ADDENDUM NO. 2

March 24, 2021

Additions & Renovations to Pleasant Run Elementary School 1800 North Franklin Road Indianapolis, IN 46219

TO: ALL BIDDERS OF RECORD

DRAWING NUMBER C501

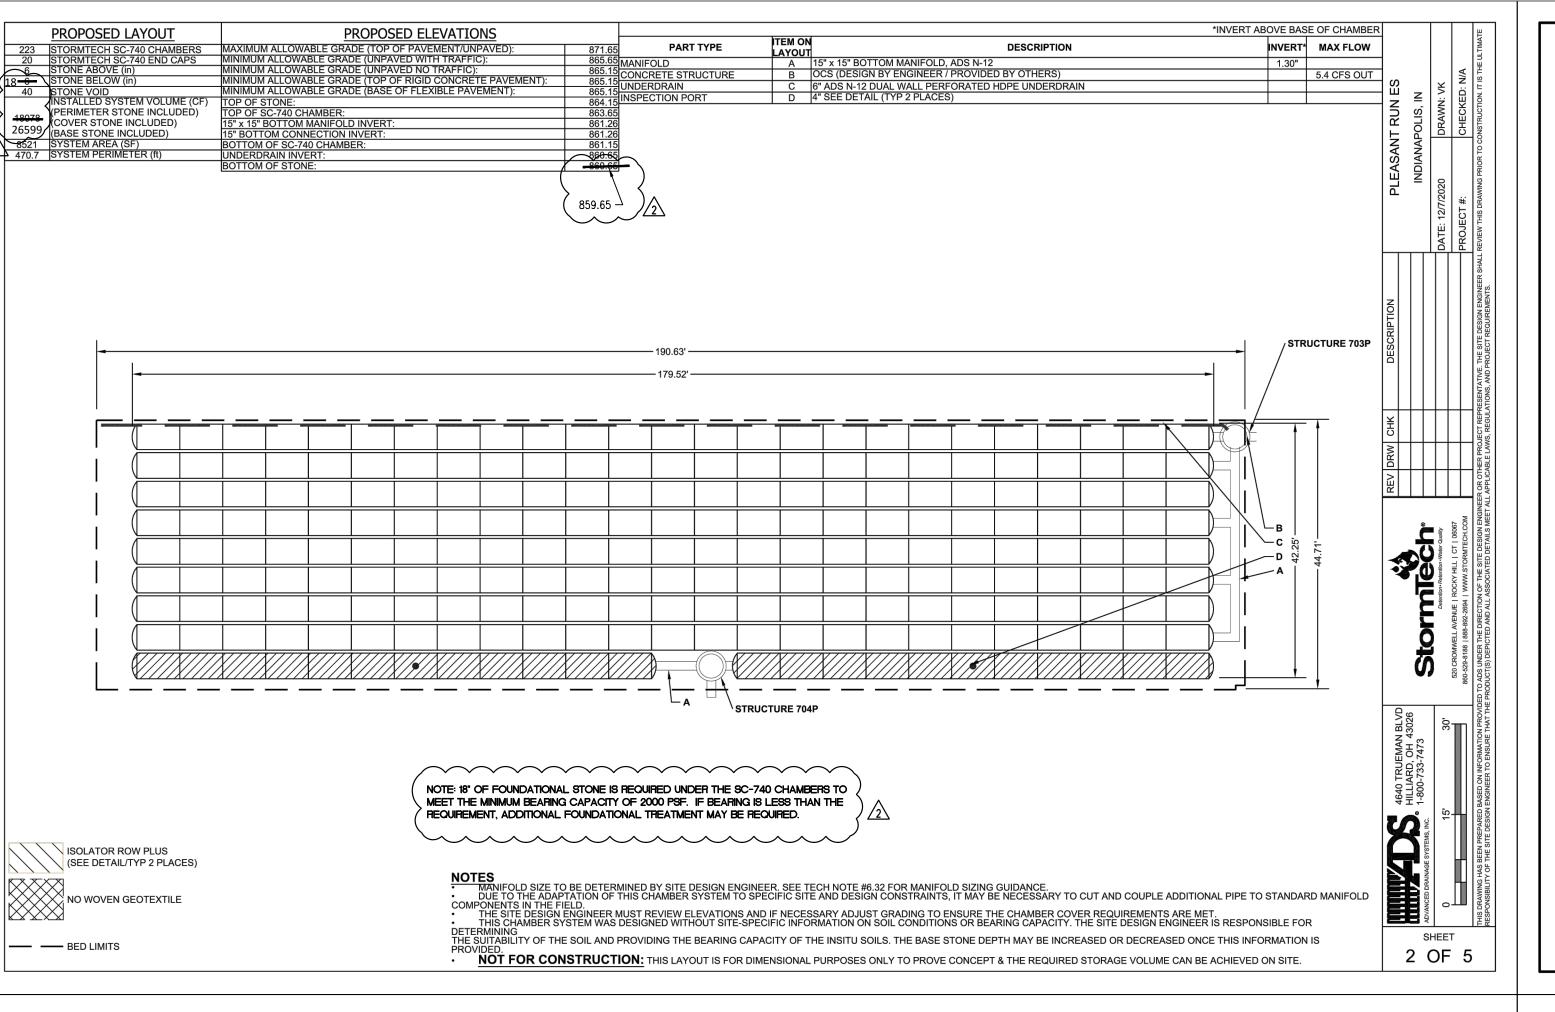
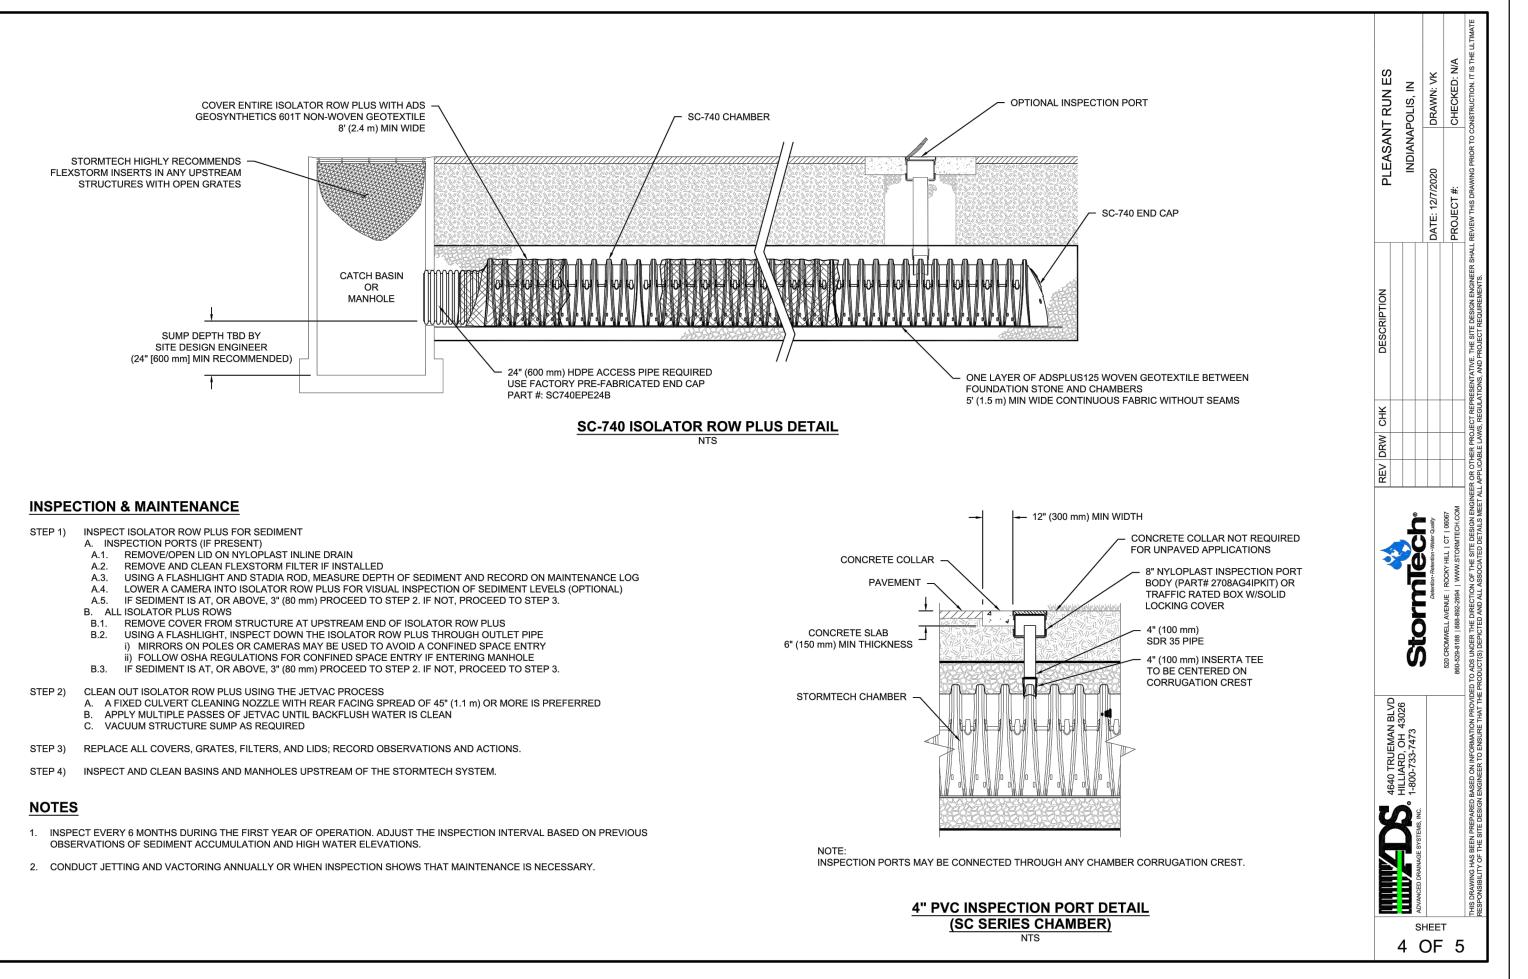
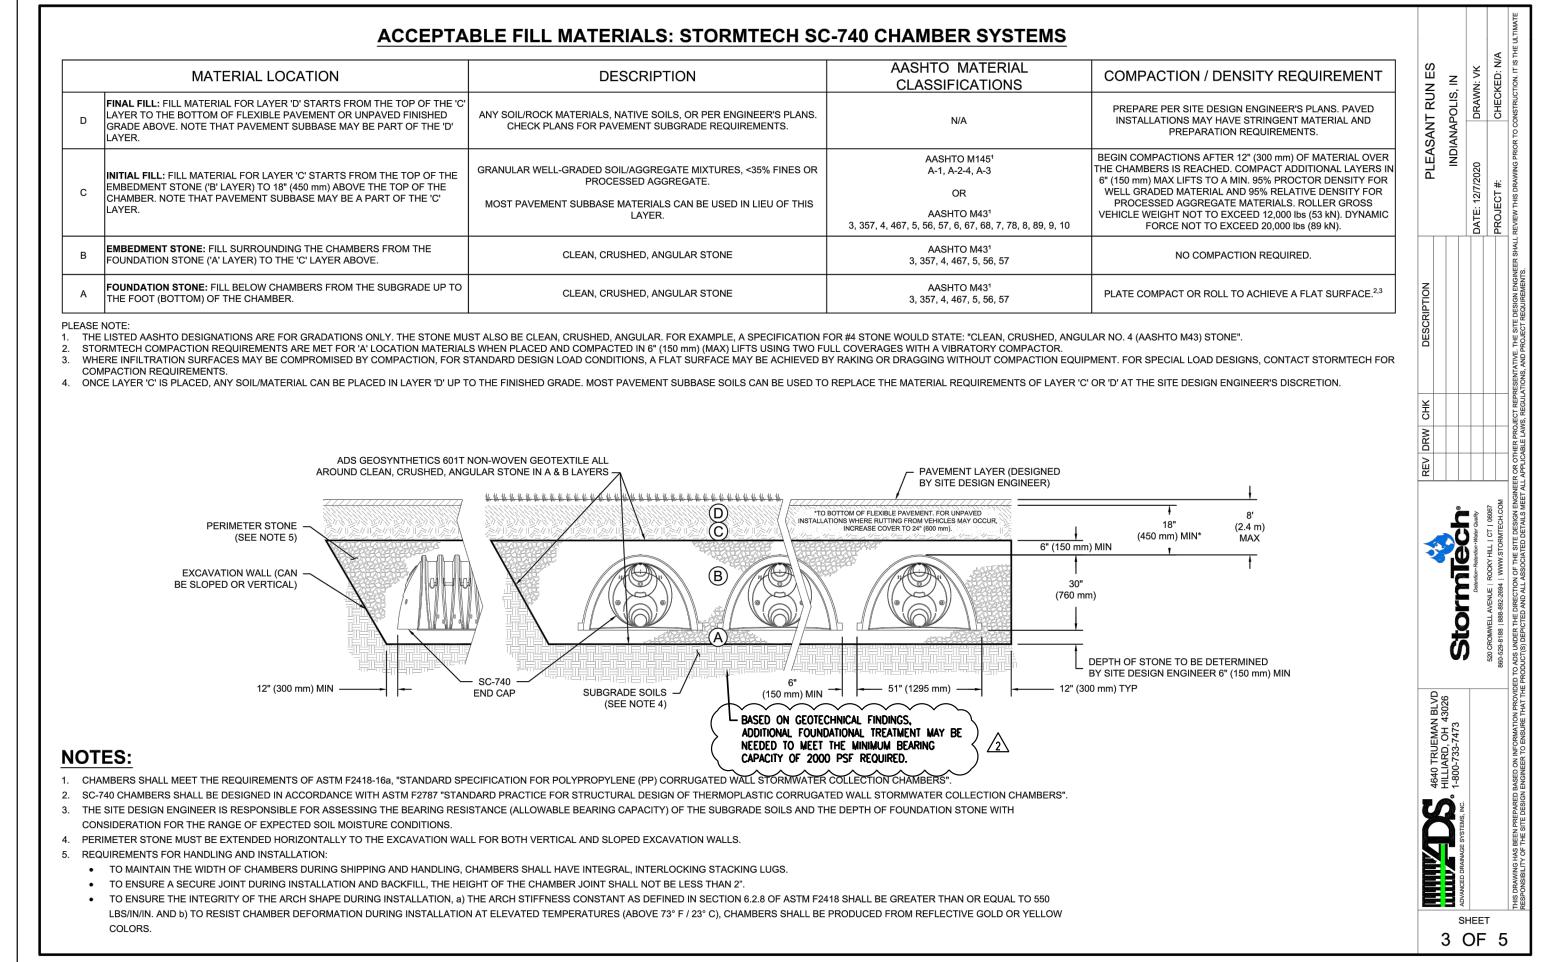
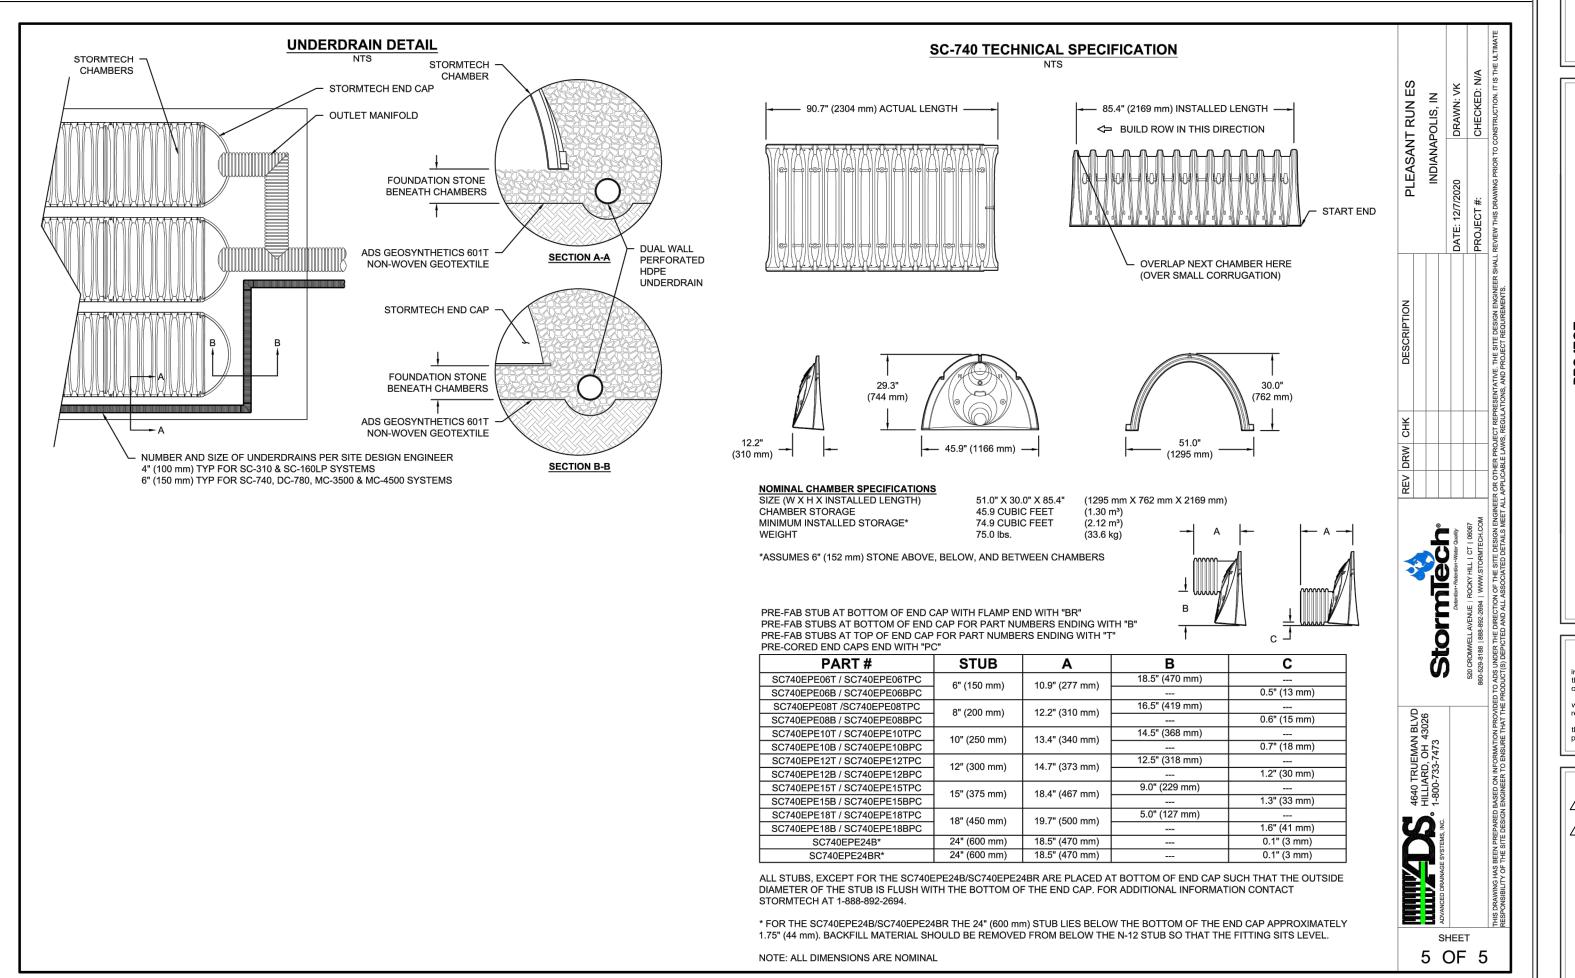
- 1. C101 Existing Conditions and Demolition Plan
 - a. Revise keynote 38.
 - b. Add leader with keynoter 45.
- 2. C501 Utility Plan
 - a. Revise stone below the chambers to 18 inches.
 - b. Revise base of stone elevation to 859.65.
 - c. Revise keynotes 33.
 - d. Add keynote 41.
 - e. Swap the location of the FDC and the PIV with the fire lines respectively.
- 3. C504 Utility Details
 - a. Revise detail information.
 - b. Revise notes.
- 4. L500 Site Details
 - a. Details 1, 2, 4, and 6 have been updated to reflect the recommended paving thicknesses per the geotechnical report.
- 5. Traffic Signal Modernization
 - a. Replace Current Sheet with the Attached.
